**Sent:** 26/03/2020 5:12:21 PM  
**Subject:** Application Number: DA2020/0192  
**Attachments:** 200323 Letter to Council.pdf;

**Application Number: DA2020/0192**

**New - Demolition works and construction of a dwelling house including swimming pool**

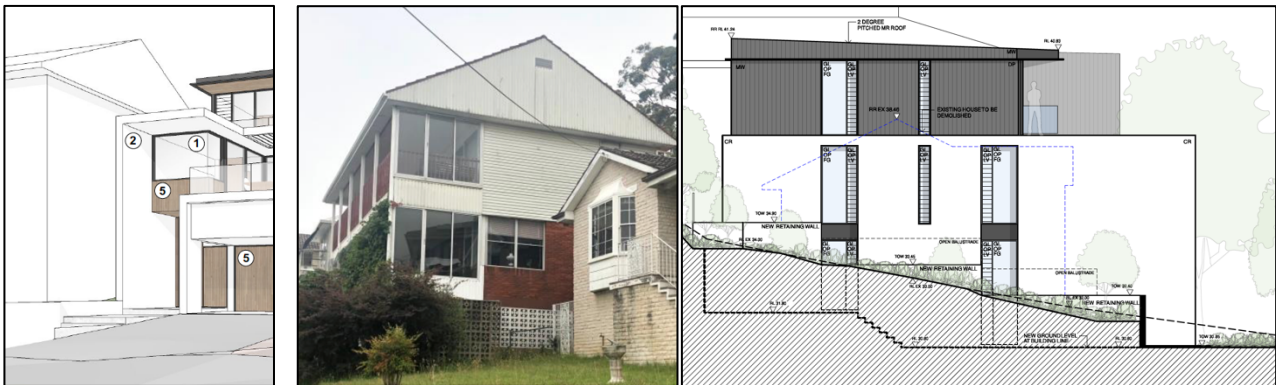
We wish to object to this Proposal on grounds of substantial loss of amenity, along with loss of primary view from the Living/Study area and the outdoor Entertaining area. (John's daily routine includes sitting at his desk enjoying the view of the harbour along with meals at his table and chairs on the balcony).

The proposed 7.6m high masonry wall to the north/south boundary is both overbearing and imposing. Refer to figures below:

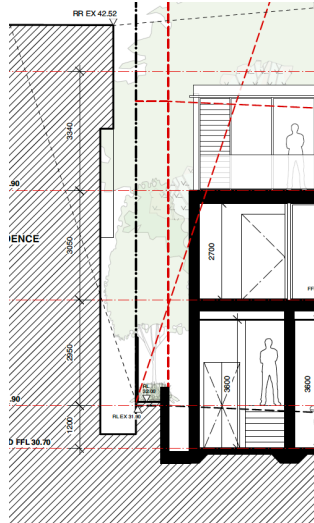
*'whether a more skilful design could provide the applicant with the same development potential and amenity and reduce the impact on the views of neighbours'.*

**We request on behalf of John that templates be erected to assess the impact of this Entry wall in accordance with of Objectives of Clause 3c**

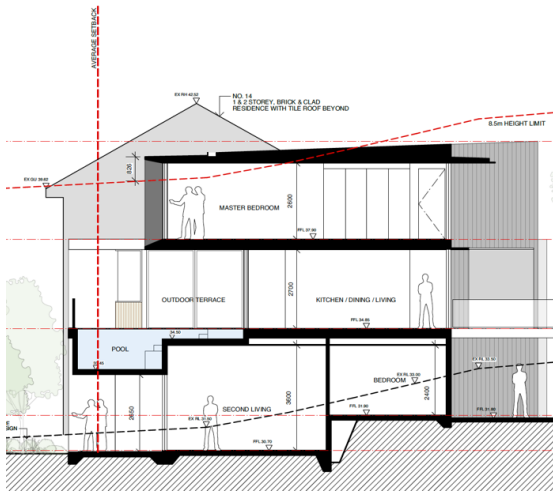
The proposed development indicates a 7657 solid wall with no fenestration or screening to allow airflow. It is also proposed to excavate a further 3000mm (refer to section) below existing ground level. In effect this wall will be 10.6m high.

Referring to the above Figure. Geotech Report notes maximum excavation of 2m. This section indicates excavation of over 3m (when taking into account thickness of slab and required excavation to prepare for slab – so 10.6m to excavated level of footpath.

We would like confirmation that the height of this wall complies with Figure 28 - Maximum Wall Height Determined by Slope – as no dimensions besides setbacks to boundaries are provided with Application.

Referencing the figure above the proposed design is not in alignment with the de facto building line.
